5
		B0200035

SB, Solar Mower, Auto Mower 1999-2000 upgrade kit, single blade disc, 2002-04

Kit 535 0986-02

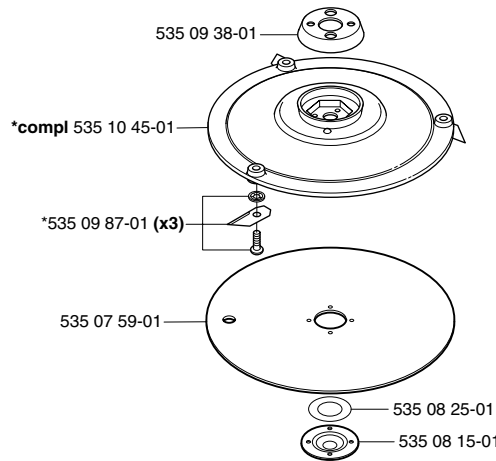
The upgrade brings several advantages. The single type blade disc (standard from 2001) will stay cleaner and therefore well balanced better than the double disc type. This increases the blade motor life. The single disc also facilitates the use of the new and much cheaper blade type 535 09 87-01, which quickly helps paying off the upgrade cost.
